PR-7007 STEREO IMPACTEPT TB Door test failure

2005-02-11

Assembly: SEPT-E (FM2)		SubAssembly: Door	
Component/Part Number:		Serial Number: FM2	
Originator: Lil Reichenthal		Organization: GSFC	
Phone : 301-286-5634		Email: Lillian.S.Reichenthal@nasa.gov	
Failure Occurred √ Functional test	d During (Check one √) Qualification test	S/C Integration	Launch operations
Environment when failure occurred:			
Ambient	Vibration	Shock	Acoustic
√ Thermal	Vacuum	Thermal-Vacuum	EMI/EMC
Problem Description			
During the Hot Door Actuation SEPT-E Behind (FM2) rear proton door did not open. The electron door that is opened by the same pinpuller did open. Pinpuller actuation was nominal. Reference STEREO Thermal Balance Test Plan, STEREO-GSFC002.C, p14, Sec. 8. Conditions: 44C (hot soak), Time: 12:12 p.m., Pressure 4.5 x 10-7 Torr. (See the next page for a more thorough description.)			
Analyses Performed to Determine Cause			
The chamber was opened and it was apparent that the MLI was interfering with the door. The MLI was gently pressed and the door immediately opened. Reference photos taken when the chamber was opened.

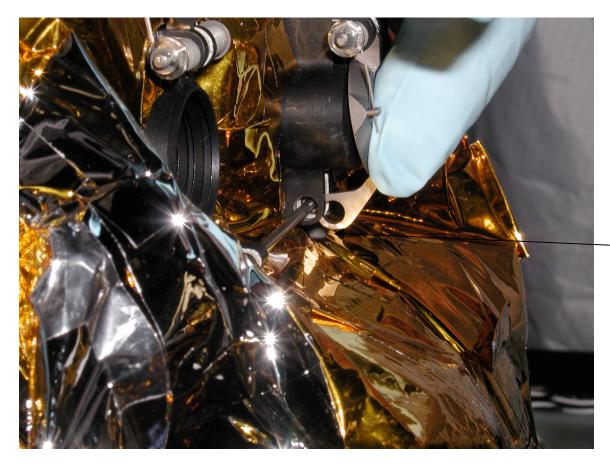
The chamber was opened on 3/9/05 at $\sim 10:30$ am and it appears that the blanket interfered with the door's latch-hook. Photo documentation of the interference points was collected at that time.

March 9, 2005 The door had opened while transitioning from hot to ambient. SEPT-NS FM2. (S/N 04). Note the contact between the door mechanism and the blanket.

Retested actuation of the SEPT-NS doors both hot and cold with the new flight blanket configuration. (WOA 545-289). All doors opened freely.

New blanket design which featured 2 blankets. One that was fitted around the apertures and one for the base of the unit. This new design that was implemented on all flight units. Note the clearance around the door mechanism.
